To: City of Phoenix Planning Commission **Date:** October 31, 2025

Subject: ITEM NO. 10 (Z-103-25-8) – APPROXIMATELY 570 FEET WEST OF THE NORTHWEST CORNER OF 27TH AVENUE AND BASELINE ROAD

Rezoning Case No. Z-103-25-8 is a request to rezone 1.89 acres located approximately 570 feet west of the northwest corner of 27th Avenue and Baseline Road from S-1 (Ranch or Farm Residence) to C-2 (Intermediate Commercial) to allow for commercial uses - a bank and restaurant.

Elevations date stamped October 20, 2025 (2 pages)

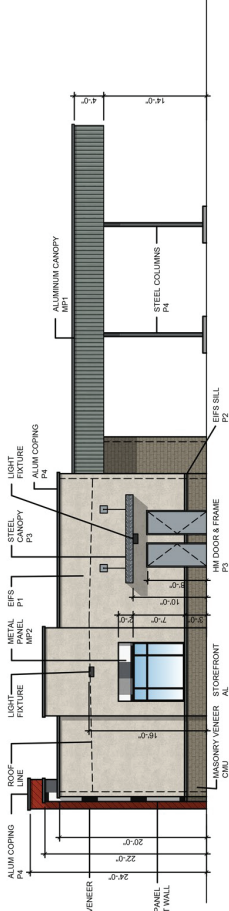
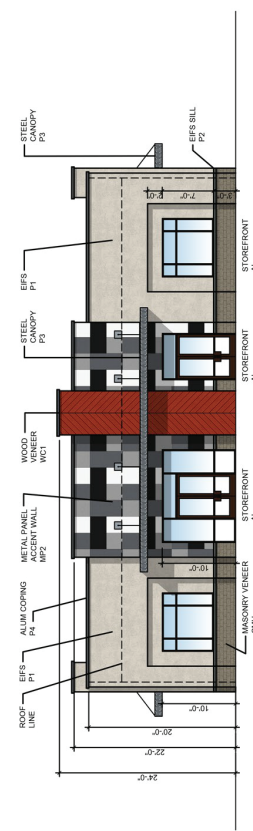
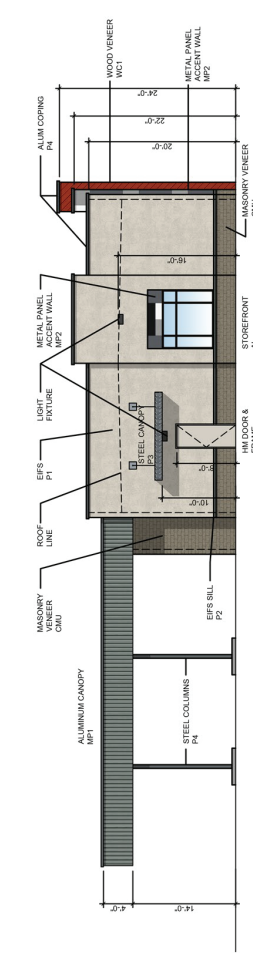
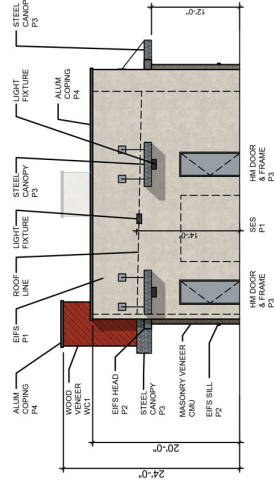
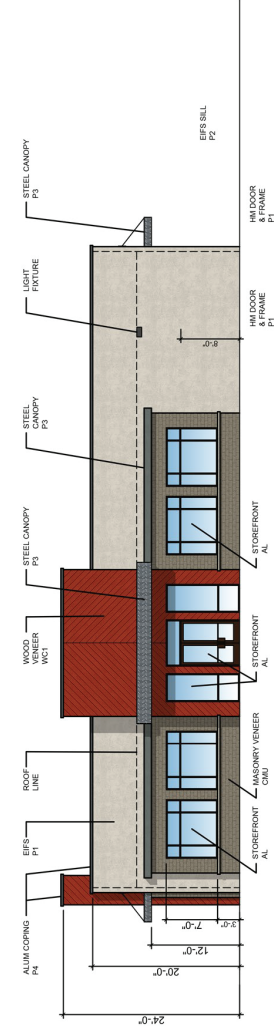
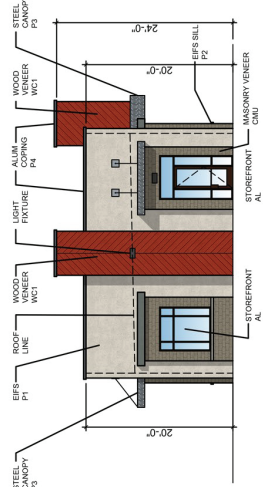
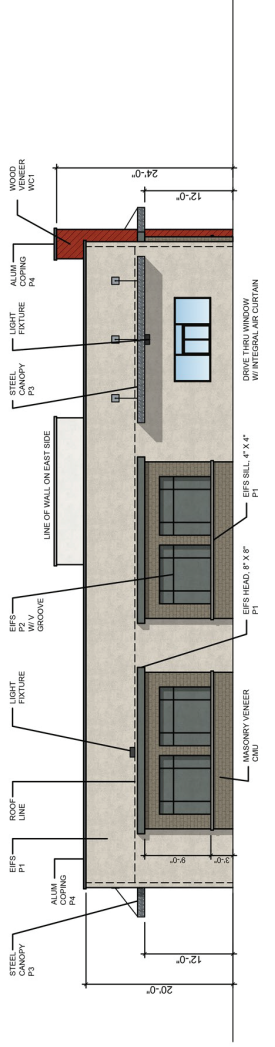
The applicant presented revised elevations during the VPC meeting (attached). That is reflected in Stipulation No. 2. Staff has no concerns with the modified language of Stipulation No. 3, requiring a minimum of 25% non-stucco accent materials on perimeter street facing elevations. To ensure compliance, staff recommends modifying the language in Stipulation No. 4 to require the review and comment of the landscape and sign plans prior to preliminary site plan approval.

2. THE DEVELOPMENT SHALL BE IN GENERAL CONFORMANCE WITH THE ELEVATIONS DATE STAMPED OCTOBER 22, 2025, AS MODIFIED BY THE FOLLOWING STIPULATIONS AND APPROVED BY THE PLANNING AND DEVELOPMENT DEPARTMENT.

2. All perimeter street facing building elevations shall contain architectural features that reflect modern agrarian architecture AND SHALL CONSIST OF A MINIMUM 25% NON-STUCCO ACCENT MATERIAL including, but not limited to, ~~DETAILING SUCH AS~~ pitched roof elements, variation in window size, overhang canopies and exterior accent materials such as metal, wood, and stone, as approved by the Planning and Development Department.
